**Proposed Parking Site Developments at Lucan Demesne,
Lucan, Co. Dublin,**

Road Safety Audit Stage 1

Document Control Sheet	
Document Reference	11194-TR01-RSA
Report Status	Issue
Report Date	July 2021
Current Revision	A
Client:	South Dublin County Council
Client Address:	County Hall, Belgard Square North, Tallaght, Dublin, D24YNN5
Project Number	11129

Figure 2-2: Proposed dimensions for parallel parking bays at Site A

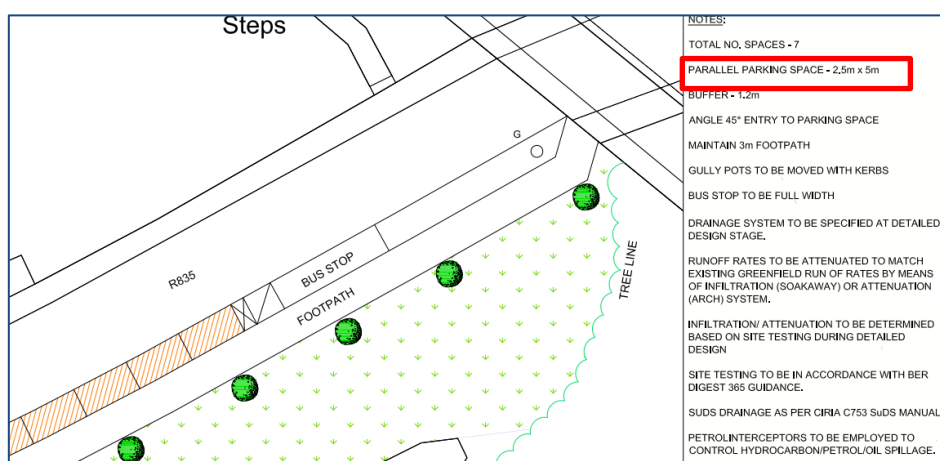
Parallel parking space dimensions are of insufficient length. This may result in difficulty manoeuvring into / out of spaces resulting in parked collisions, and increased potential for rear end shunts between vehicles parking and passing traffic.

The Design Team should provide suitably sized parking bays for safe manoeuvrability.

2.1.1	Yes	yes		
2.1.2	Yes	yes		
2.1.3	Yes	No	Current drawings do not specify that the bus stop is to be "in-line" in conjunction with a kassel kerb. The bus will not need to manoeuvre off the carriageway to stop. This is representative of the existing condition and as such is deemed acceptable. Drawing to be amended with a note clarifying that the bus stop is to be an in-line stop with a kassel kerb

Figure 2-3: Site A: Bus stop width

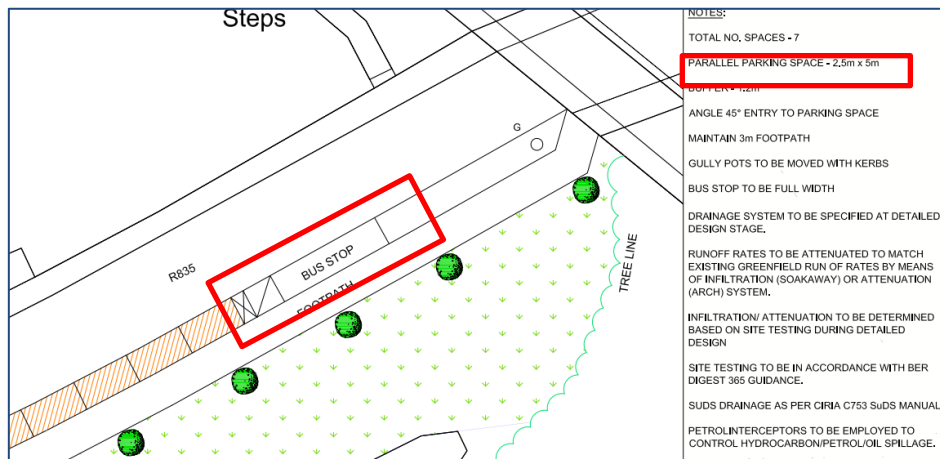
The bus lay-by is indicated in line with the parallel car parking on the R835. The Audit Team are concerned that the width of the bus lay-by will result in the stopped bus encroaching into the passing traffic. This may result in the bus being struck by passing traffic / on-road cyclists swerving around the obstruction into the path of a vehicle approach from behind.

The bus layby should be positioned so as not to obstruct passing traffic on the R385.

Figure 2-5: Existing gully appearing to clash with location of proposed pedestrian crossing

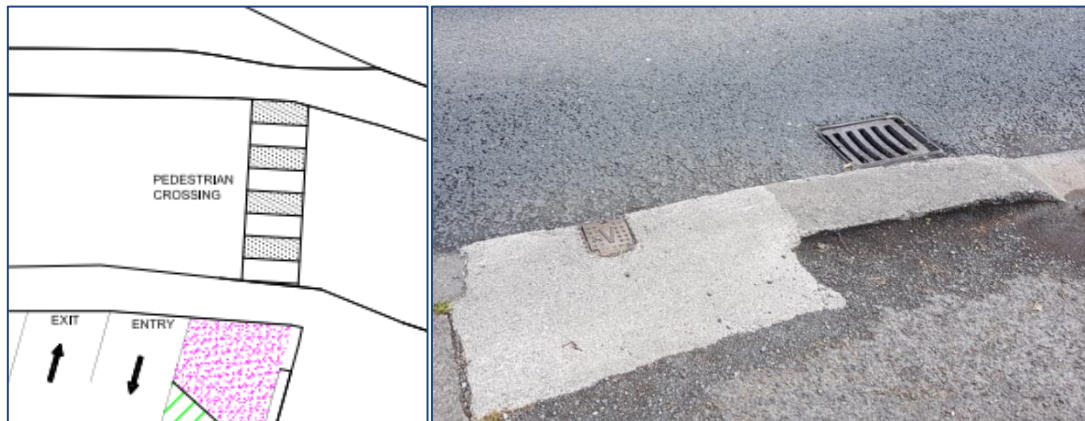
Existing gully appears to be in line of proposed pedestrian crossing. Potential for ponding of water / built up of debris leading to slips / trips and in cold weather ice may form at crossing leading to slips. There is also the potential for visually impaired walking aids to become stuck in the grating.

The Design Team should relocate gully upstream of the pedestrian crossing.

2.1.4	Yes	Yes		
2.1.5	Yes	yes		
2.2.1	Yes	No	Rather than re-locate the gully, it is intended to amend the design and relocate the pedestrian crossing.	
2.2.2	Yes	Yes

Figure 2-7: Possible visibility clashes with Parking spot WA2 and Soft landscaping to East

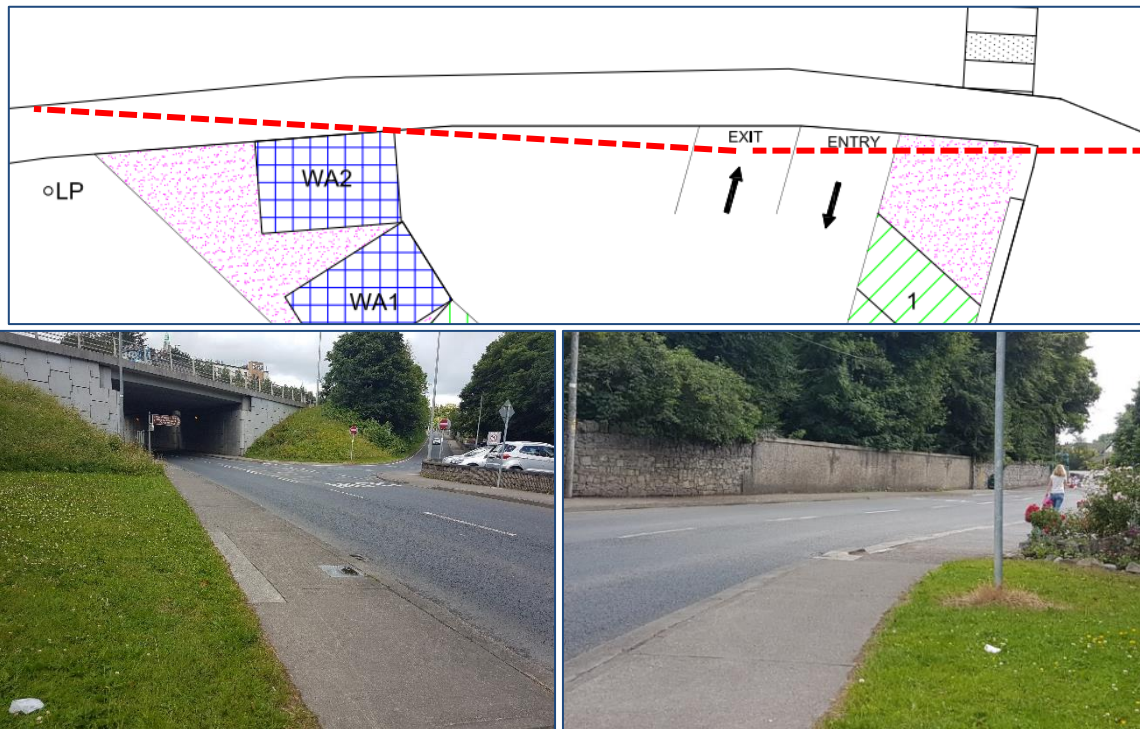
No details of the visibility splays were provided. The Audit Team are concerned that the visibility splays existing the carpark may be impacted by landscaping, boundary treatment and high sided parked vehicle in WA2. Obstructed visibility may result in a vehicle encroaching into oncoming passing traffic on the R835 and the vehicle being struck by passing traffic.

The design team to ensure adequate visibility splays are provided and that no obstructions are within driver eye line.

Figure 2-8: Operation of Parking Space 1

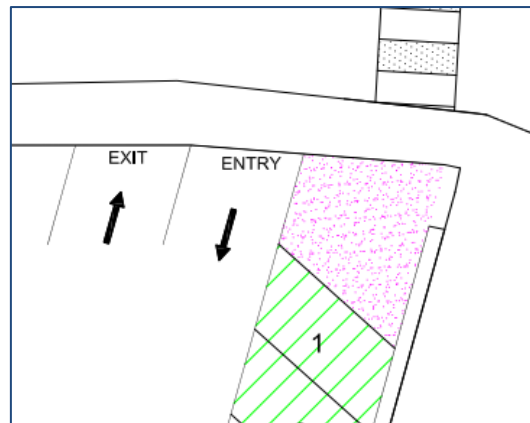
The Audit Team note on Drawing No. 3108-03 that vehicles on entry to the carpark will requires a tight turn to enter parking space no. 1 and will occupy the carpark entry lane for manoeuvring into / out of this space. This may result in vehicles waiting to enter the carpark overhanging the footpath and protruding into the R835 carriageway. This may result in rear end / side swipe collisions.

The Designer should ensure that adequate clearance is provided between passing traffic along the R835 and vehicles waiting to enter the carpark.

Figure 2-9: Potential Conflict Point between existing 50kph repeater sign and proposed Pedestrian Crossing

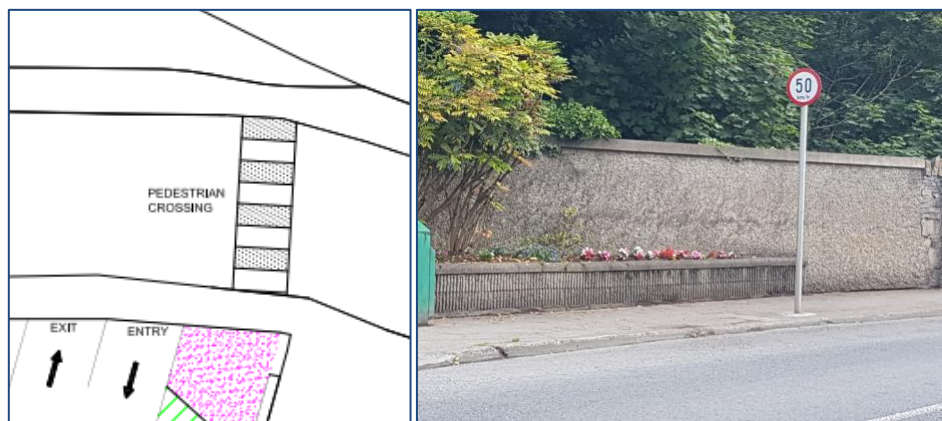
The Audit Team note that the location of the 50kph repeater sign on eastbound side of the R835 will potentially clash with the proposed pedestrian crossing infrastructure and pedestrian movements leading to a conflict point.

The Designer should ensure that sign is sited clear of pedestrian interface to the back of footway.

Figure 2-10: Dimensions of the Proposed Wheelchair Accessible Parking within Site B

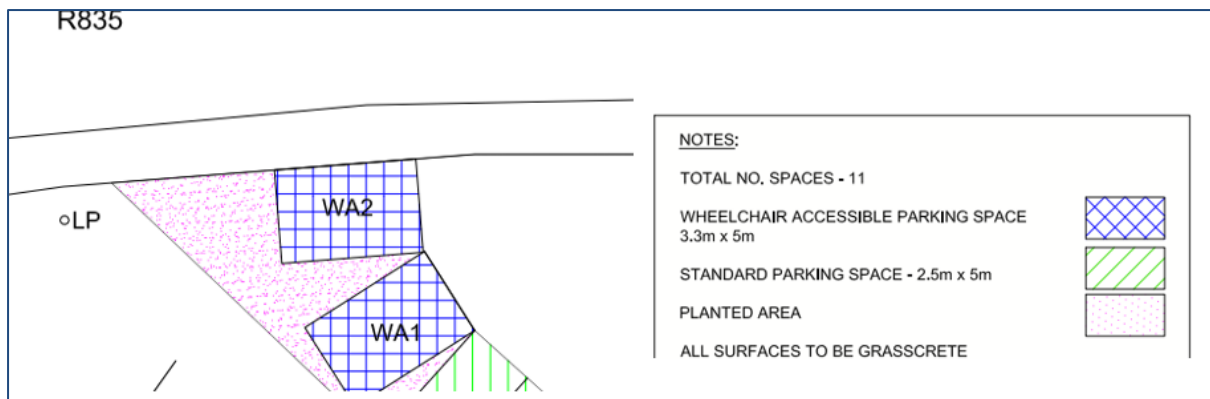
Proposed wheelchair accessible parking space indicates dimensions below those required for suitable manoeuvrability around a parked vehicle. This may prevent a vulnerable road user from safely accessing/ egressing the designated spaces and result in the vulnerable road user being stationary within a conflict area with vehicles reversing / manoeuvring into adjacent parking spaces.

The Design Team should provide wheelchair accessible parking with adequate manoeuvrability for access / egress from the vehicle within the designated space.
